DOCKET 50-312  
RANCHO SECO NUCLEAR GENERATING STATION  
UNIT NO 1  
ADDITIONAL INFORMATION ON ALTERNATIVE SHUTDOWN CAPABILITY FOR COMPUTER AND  
CONTROL ROOM

### NRC QUESTIONS ON DISTRICT'S 81-12 RESPONSE OF APRIL 5, 1985

SACRAMENTO MUNICIPAL UTILITY DISTRICT  
RESPONSE TO  
CLARIFICATION OF  
GENERIC LETTER 81-12

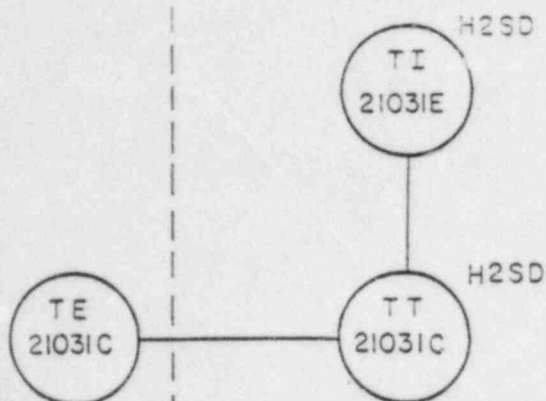
Figures SK-ISD-12 and SK-ISD-13 refer to TE-21031C and TT-21031C and TE-21032C and TT-21032C, while figure SK-J-500 refers to TE-21031C and TT-21031A and TE-21032C and TT-21032B. Please clarify.

Figure SK-J-500 has been revised to change TT-21031A to TT-21031C and TT-21032B to TT-21032C. Also interface with NNI cabinets has been deleted as this was incorrect. The updated figure is attached.

SK-J-500

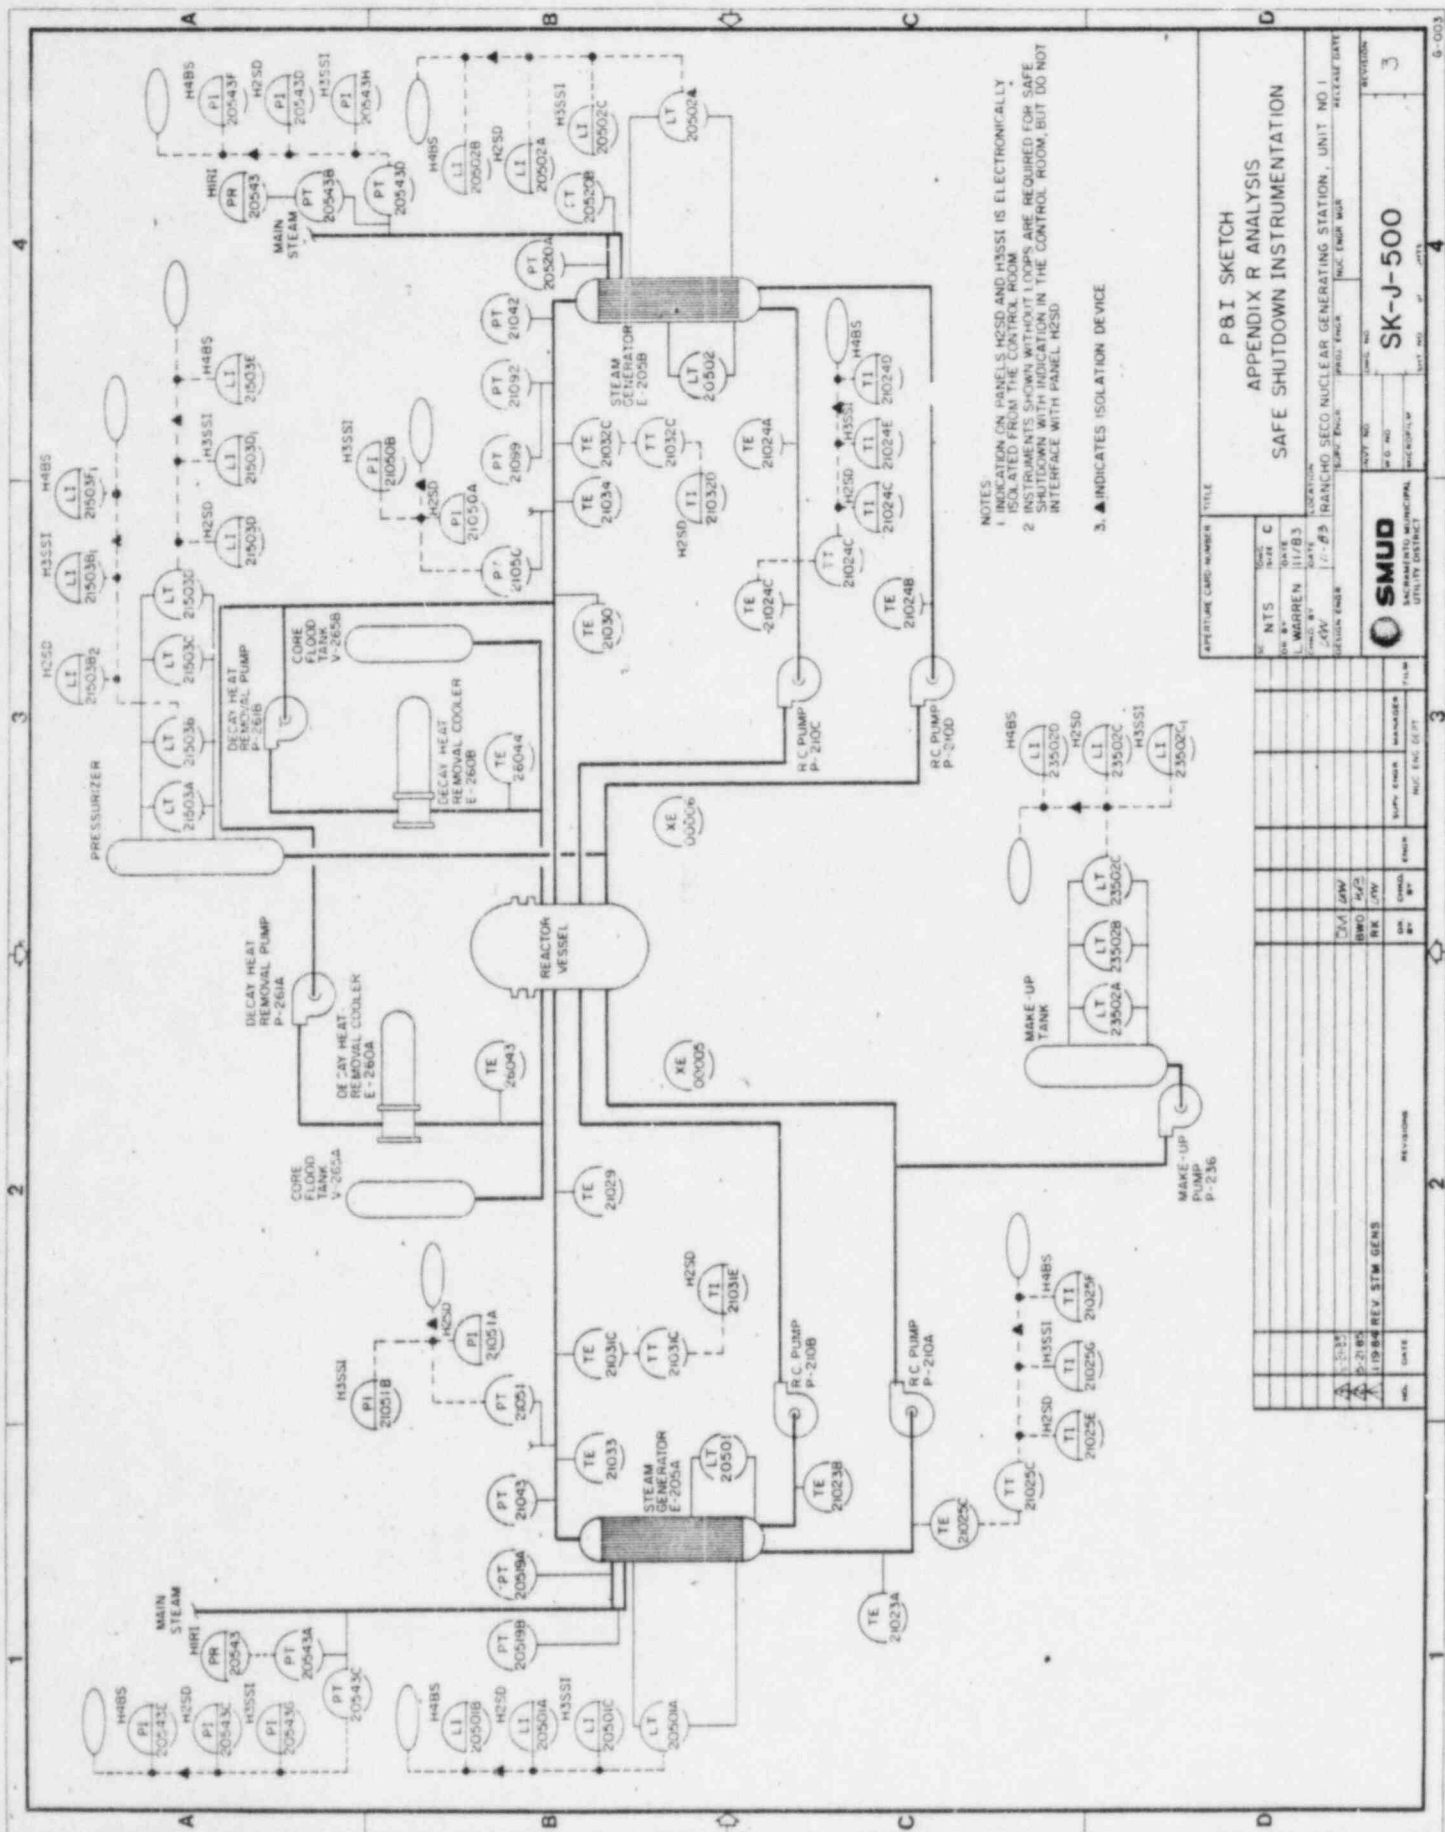
On page II-23, Table 2-1, LT-20504A is listed but it appears to be left off figure SK-J-500?

On Figure SK-ISD-8, there appears to be a "typo" because PI-21050A is in the figure but title references loop "B"? Please clarify.

OTSG wide range level transmitters LT-20501, LT-20502, LT-20501A and LT-20502A only are required for safe shutdown. Therefore, OTSG operating range level transmitters LT-20504A and 20503B and have been deleted from Table II-1 and Figure SK-J-500. Revised Figure SK-J-500 is attached.

Figure SK-ISD-8 correct. PI-21050A was incorrectly shown in loop "A" on Figure SK-J-500 and it has been corrected. Also PI-21031 was incorrectly shown in loop "B" on Figure SK-J-500 and it has been corrected. Figure SK-J-500 is attached.

SK-M-521

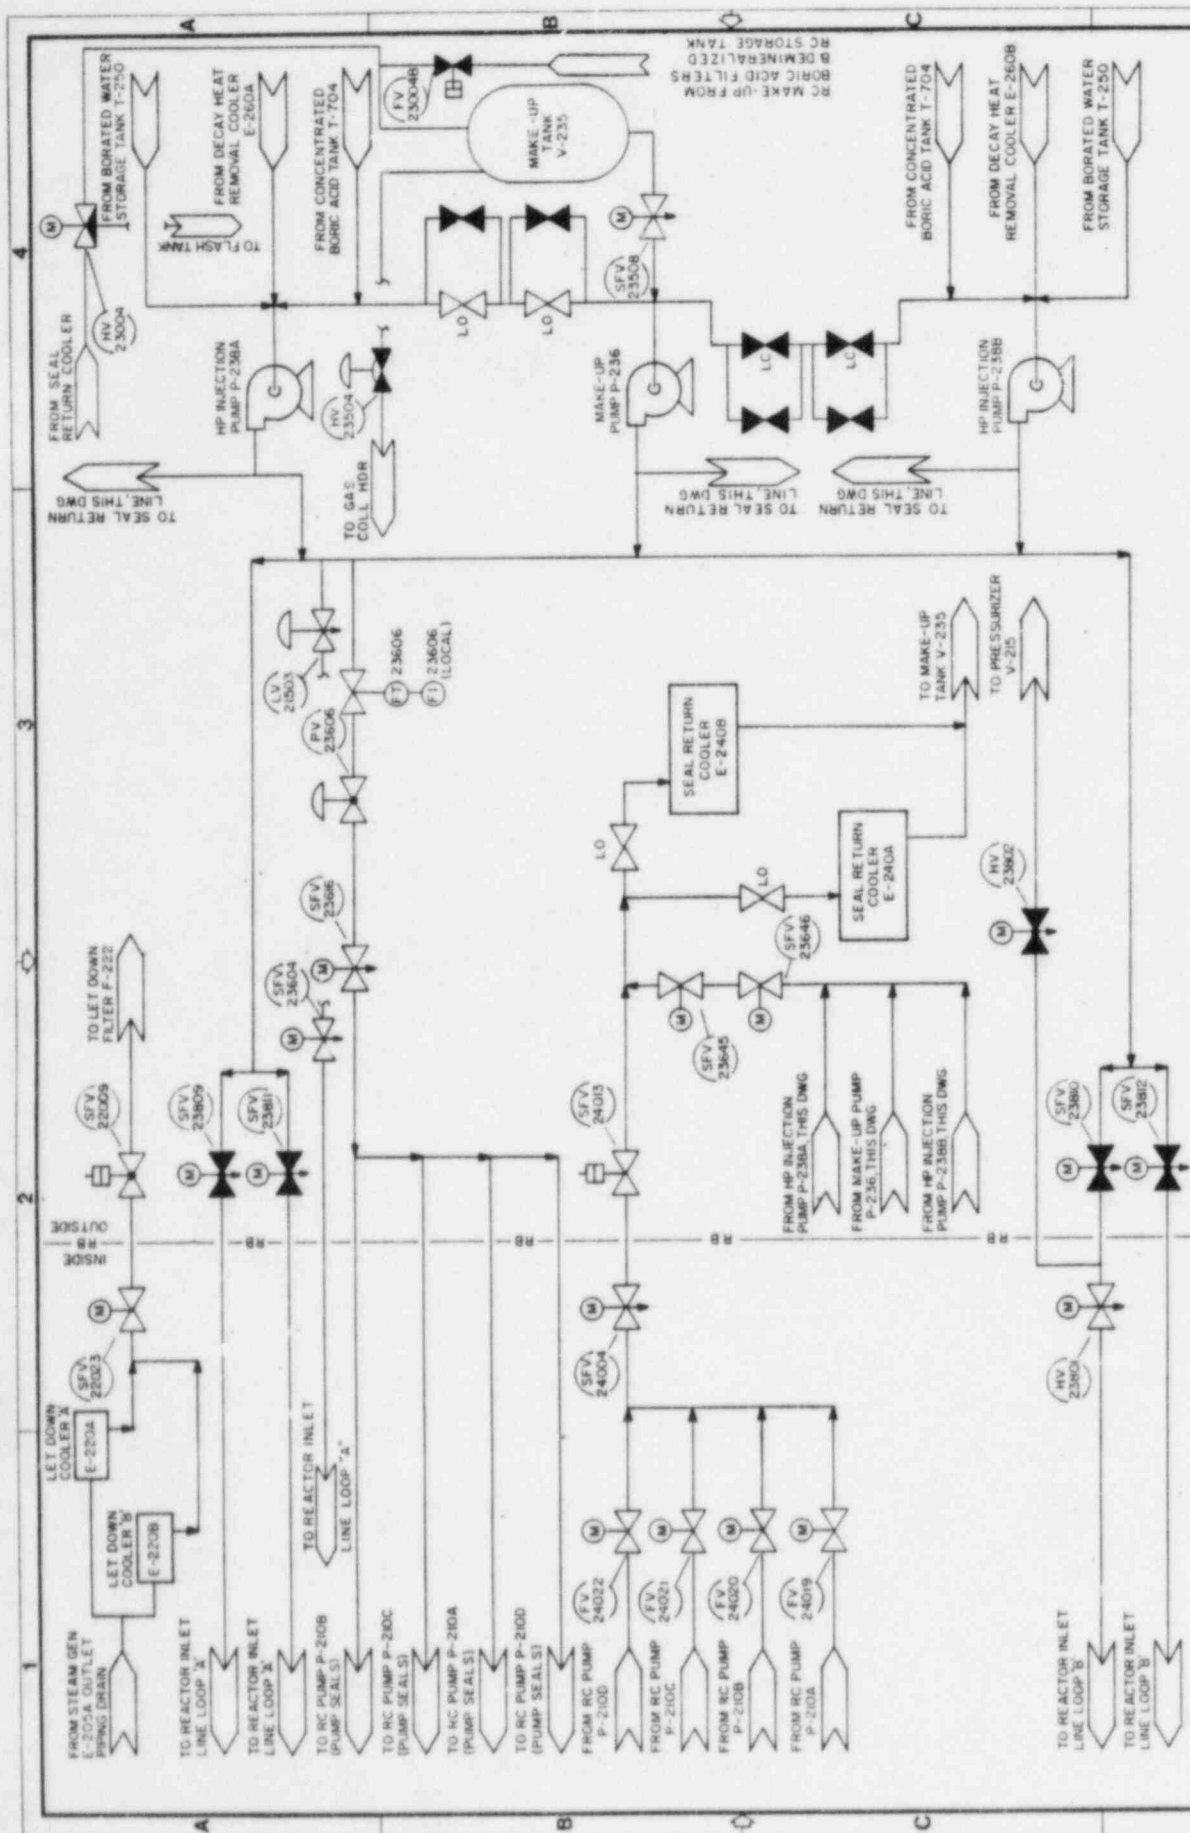
Please clarify the requirements for the HPI pump lube oil coolers.

Figure SK-M-544 has been revised to show HPI pump lube oil coolers and is attached.
